World Forum for Harmonization of Vehicle Regulations**Working Party on General Safety Provisions****104th session**

Regulation No. 110 (Specific equipment for CNG)**Proposal for amendments to Regulation No. 110
(Specific equipment for CNG and/or LNG)****Submitted by the Chair of the Task Force on Liquefied Natural Gas
vehicles***

The text reproduced below was produced by the Chair of the Task Force on Liquefied Natural Gas (LNG) vehicles to introduce type approval provisions for vehicles equipped with LNG propulsion systems. The proposal has been prepared as a new consolidated version (Revision 3) of Regulation No. 110. The modifications to the current text of the Regulation are marked in yellow ~~bold for new or strikethrough for deleted characters~~.

Figure 1
20 MPa filling unit (receptacle) for M₁ and N₁ vehicles

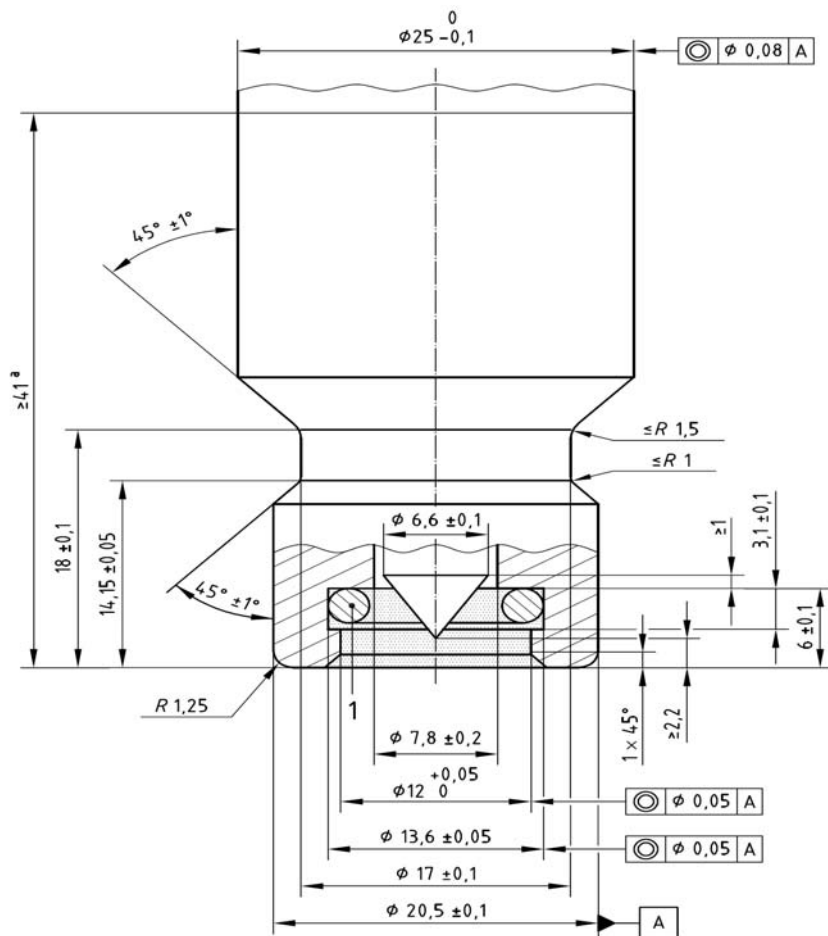
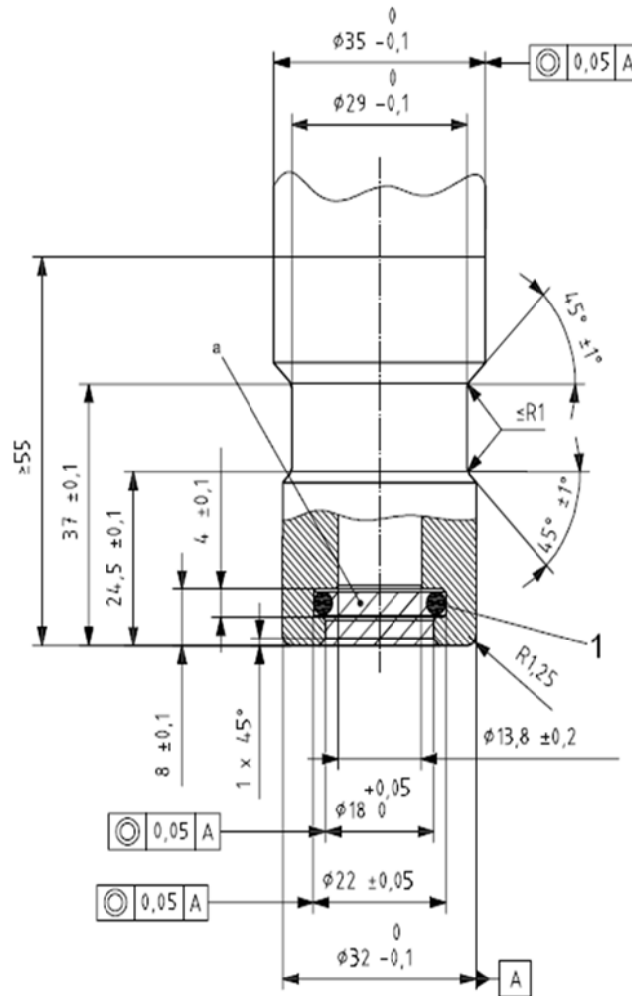
of this regulation. In this case, dimension 25 +0/-1 becomes 24 +0/-1 in Figure 1 and 35 +0/-1 becomes 34+0/-1 in Figure 2.
